Preliminary Consultation
MONTGOMERY COUNTY HISTORIC PRESERVATION COMMISSION
STAFF REPORT

Address:	29 West Kirke Street, Chevy Chase	Meeting Date:	4/24/2019
Resource:	Outstanding Resource Chevy Chase Village Historic District	Report Date:	4/17/2019
Applicant:	Katy & Bryan Anderson (Chris Snowber, Architect)	Public Notice:	4/10/2019
Review:	Preliminary Consultation	Tax Credit:	N/A
Case Number:	N/A	Staff:	Michael Kyne
PROPOSAL:	Screened-in porch alterations and new construction

Fig. 1: Subject property.

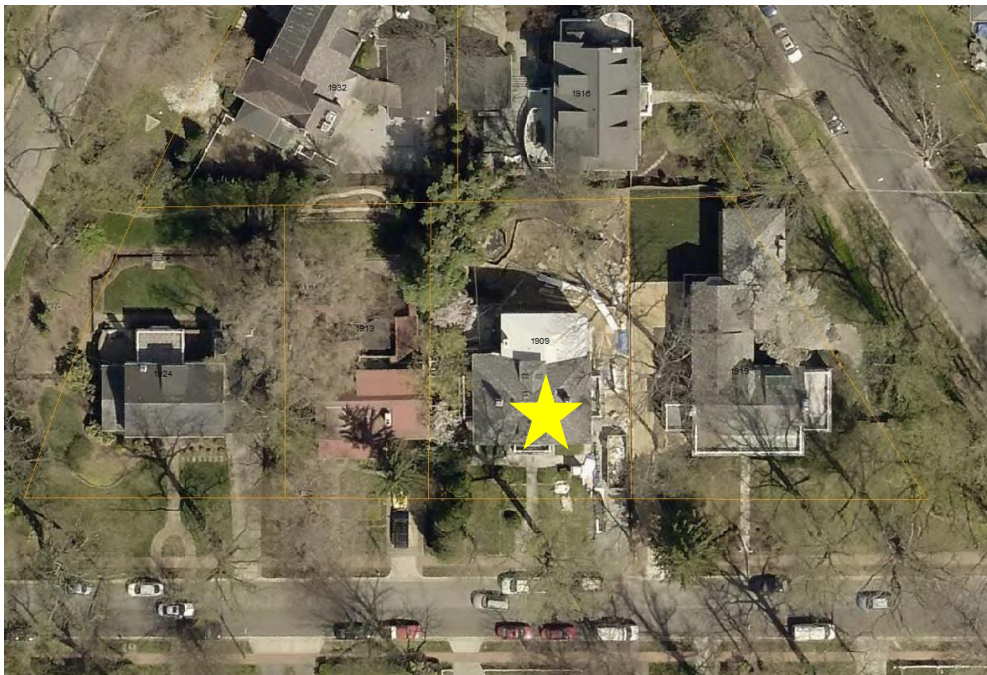
Staff is generally supportive of the applicants’ proposal; however, the proposed new screened porch will project beyond the west (left) side of the historic house and will be partially visible from the public right-of-way in the absence of vegetation. Therefore, in accordance with the *Guidelines*, the proposed new screened porch should be reviewed with moderate scrutiny.

While staff acknowledges the applicants' intention to differentiate the proposed new screened porch from the historic house, the proposed new railings will incorporate a feature that is currently only found on the c. 2014 deck, which is proposed to be removed. Staff is concerned that incorporating this feature to such a large degree (on the proposed new screened porch, on the roof of the proposed new screened porch, and at the stairs to grade) could cumulatively detract from the integrity and character of the historic house. This would be inconsistent with the *Guidelines* and with *Standard #2*, which states that the character should be preserved.

In accordance with preservation best practices, staff suggests that the applicants explore alternative railing designs, which are differentiated, yet take visual cues from existing features of the historic house. Staff asks for additional guidance from the HPC regarding the compatibility of the proposed new screened porch and alternative railing designs.

Staff recommends that the applicants make any revisions based on the HPC's recommendations and return for a HAWP application.

1 **FIRST FLOOR Proposed Plan**
SCALE: 1/8" = 1'-0"

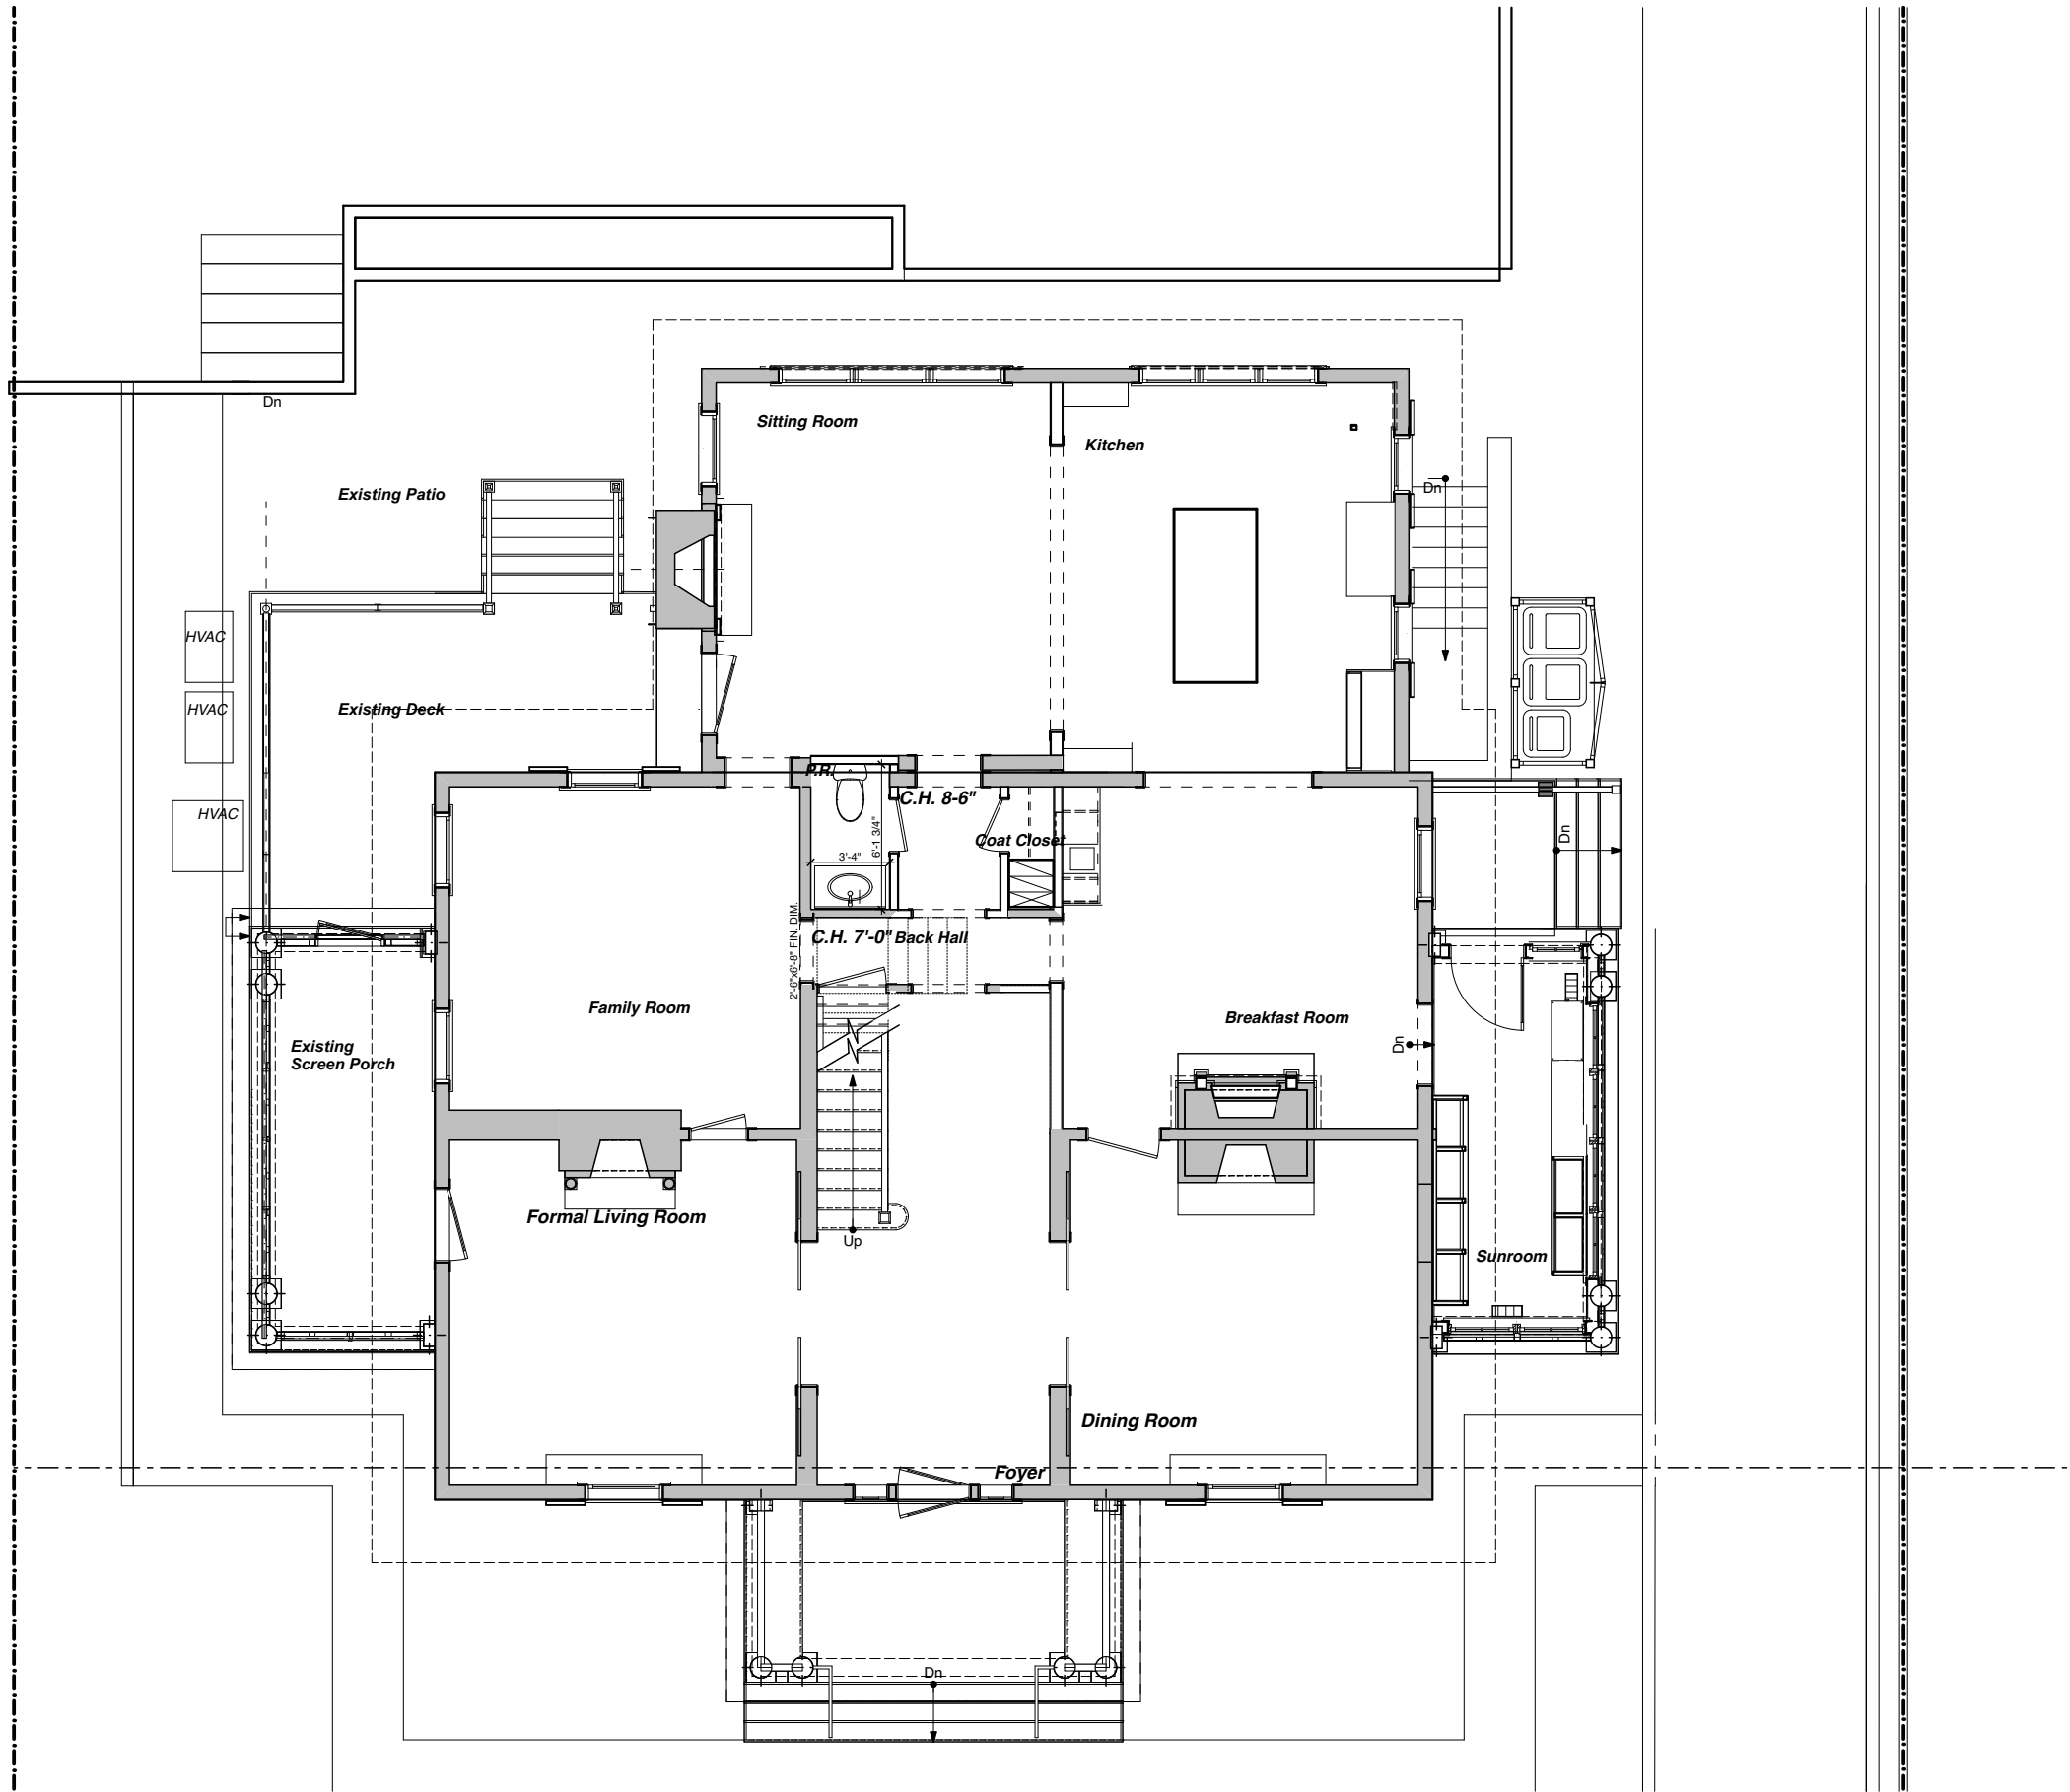
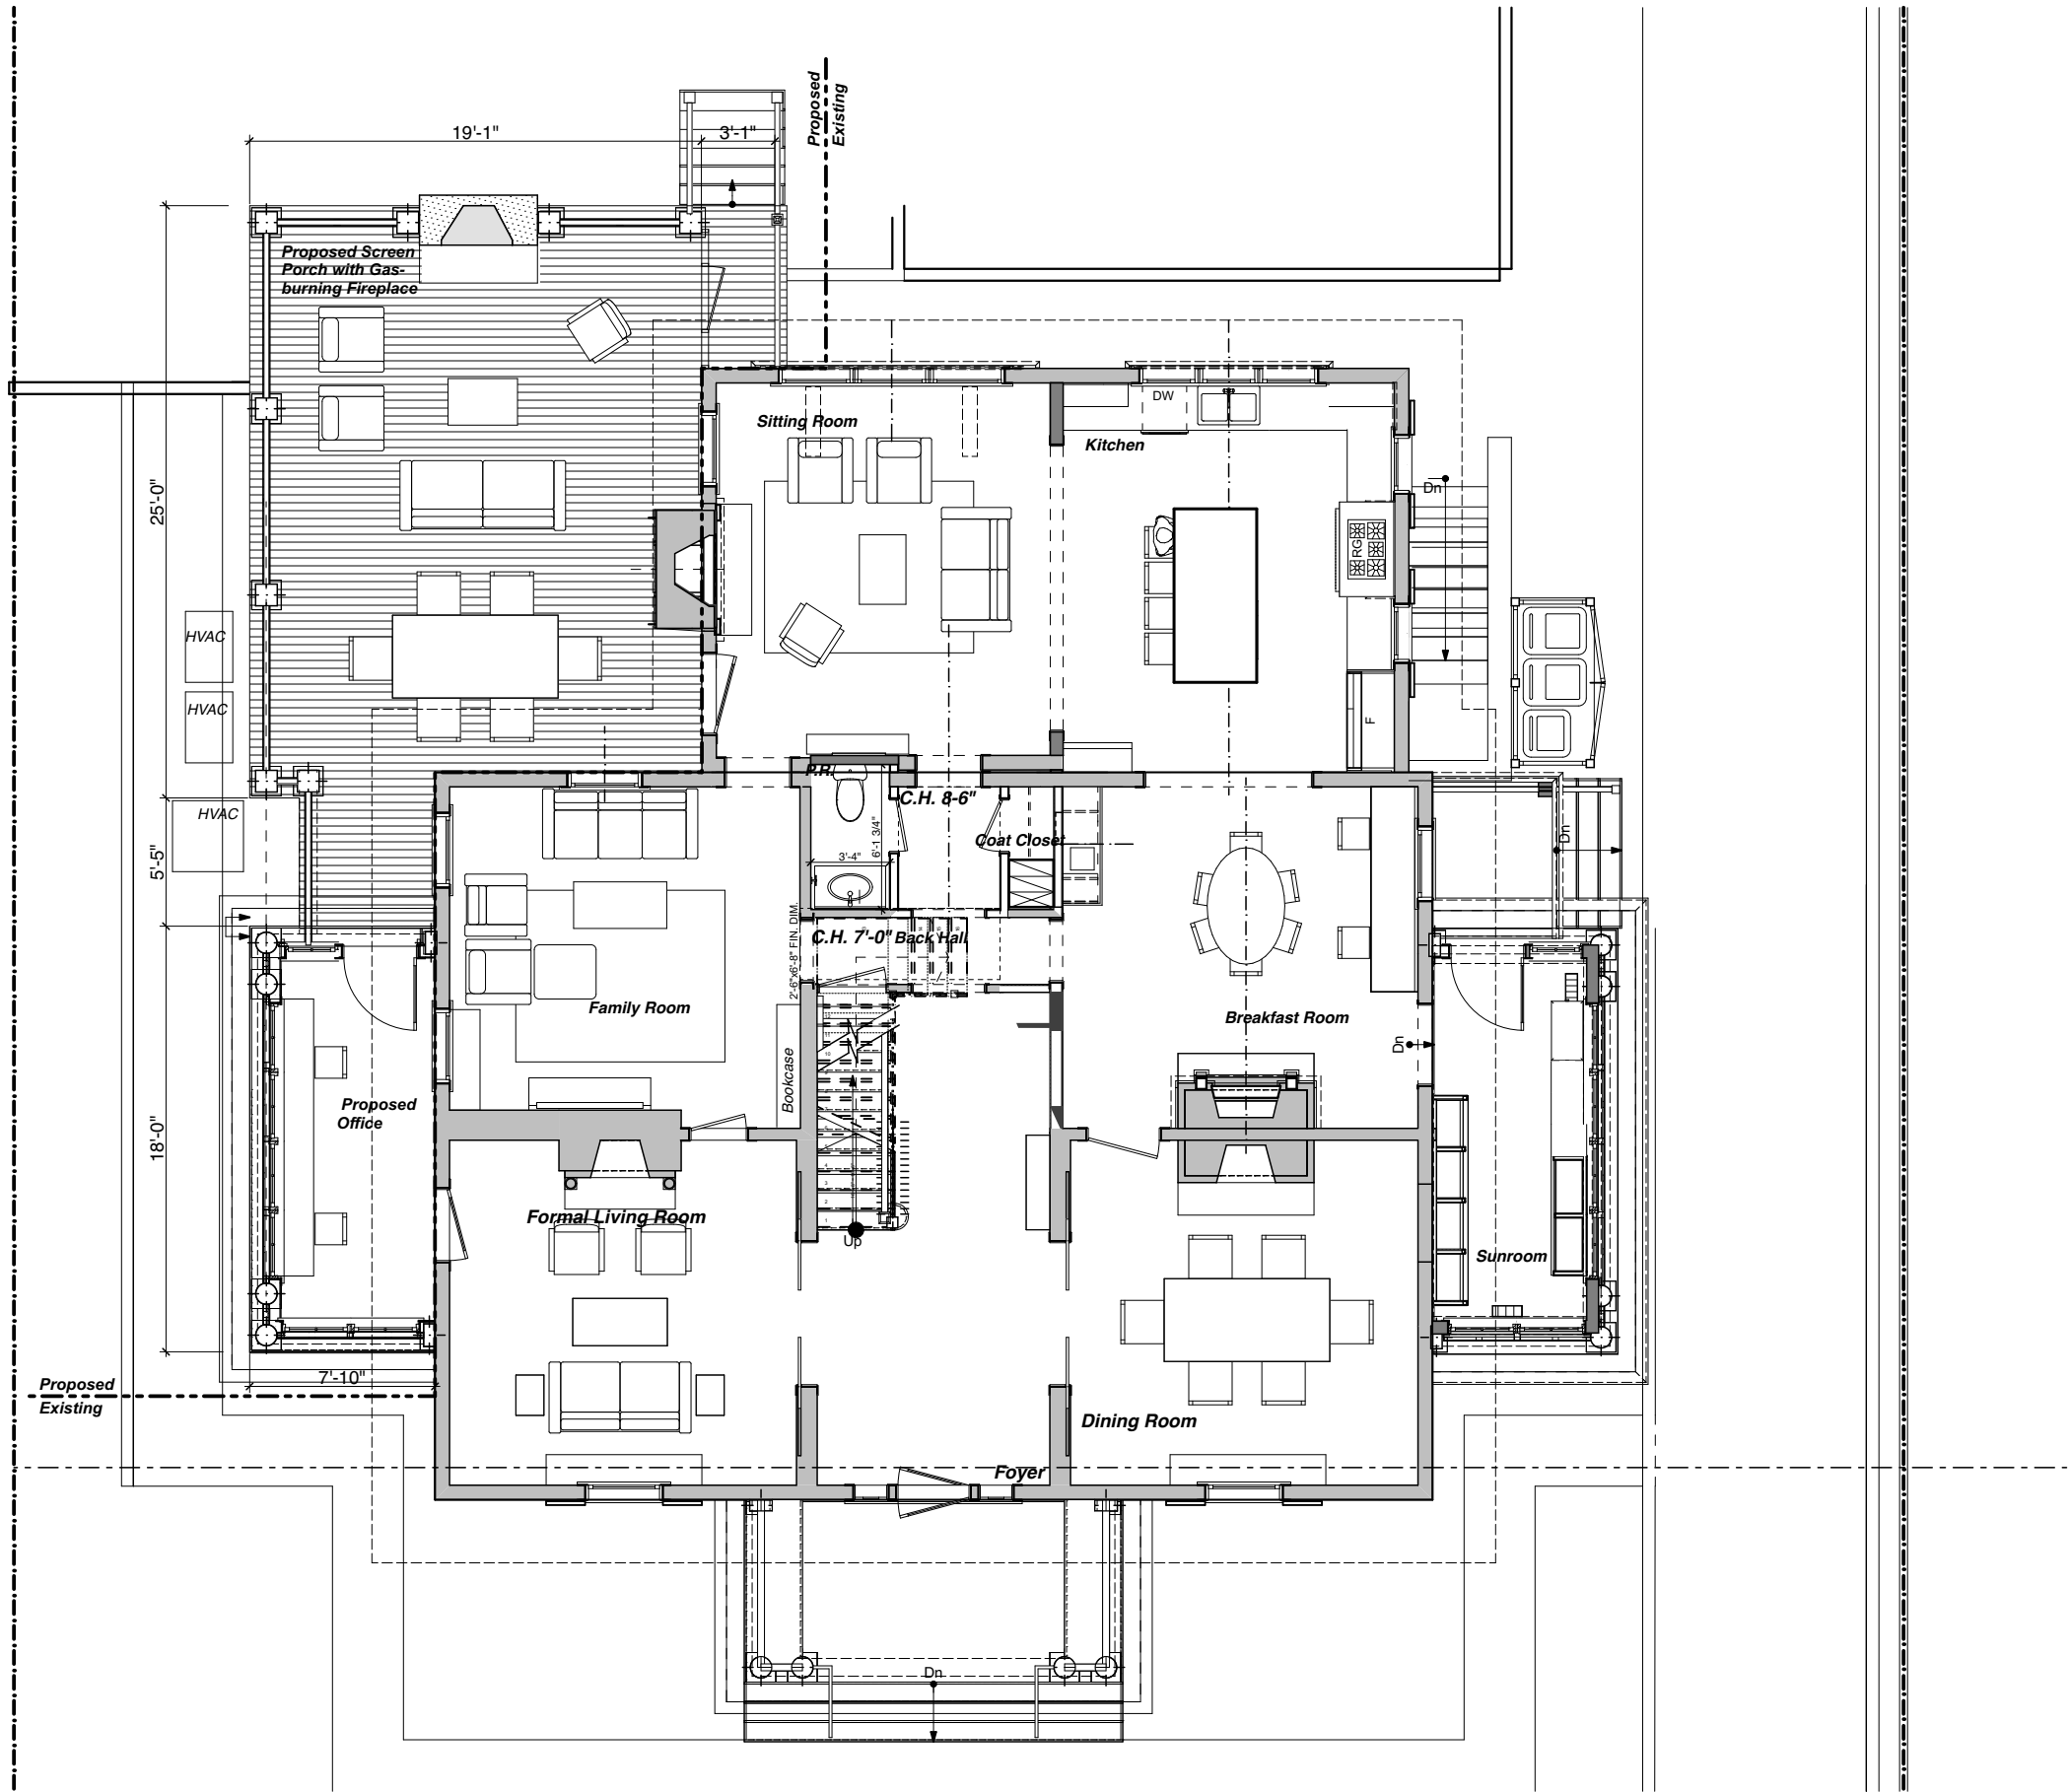
The applicants propose to enclose an existing screened porch on the west side (left side, as viewed from the front) of the historic house. The porch will be enclosed with wood walls and wooden SDL casement windows, which will be behind the existing railings, columns and entablature of the porch, preserving the visibility of these features. The proposed enclosed porch will match an existing enclosed porch on the east side (right side) of the historic house. The enclosure of the east side porch was reviewed and approved by the HPC at the June 15, 2014 HPC meeting.

- A slight inset is proposed between the existing west side screened porch and the proposed new screened porch, providing some articulation and differentiation between the existing and the proposed.
- Beyond the inset, the proposed new screened porch will be coplanar with the existing west side screened porch.
- The proposed stairs in the northeast corner of the proposed new screened porch will have traditional wooden railings to match the railings of the proposed new screened porch.

Staff fully supports the enclosure of the existing west side screened porch. The proposed porch enclosure is consistent with the *Guidelines*, which state that porch enclosures should be allowed, where compatibly designed. Staff finds that the proposed porch enclosure is compatibly designed, and that it preserves the visibility of character-defining features (i.e., the railings, columns and entablature), in accordance with the *Standards*.
